DOCUMENT CHANGE NOTICE (DCN)

DOCUMENT No. (DOC-REV-GP. ID)	TITLE	NEW REV.
D961419-B	Core Optic Component Carrier Cover Assembly	C
D961460-B	Large Core Optic Component Carrier Assembly	C
D961461-B	Beam Splitter Optic Carrier Assembly	C
D970509-n/a	Core Optic Component Carrier Valve Hole Plug, Inner	A
D970510-n/a	Core Optic Component Carrier Valve Hole Plug, Outer	A

On face of drawing, zone 2B:

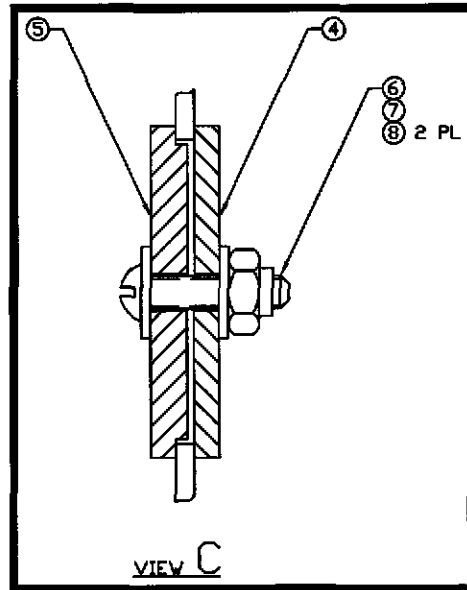
Changed main views to show plug assembly replacing breather valve.
 Added view C, and updated parts list (see sheet 2).

Added:

REASON FOR CHANGE: Breather valve on COC carrier was found to contain unacceptable materials (paint).
 Replaced with a passive aluminum plug by this change.
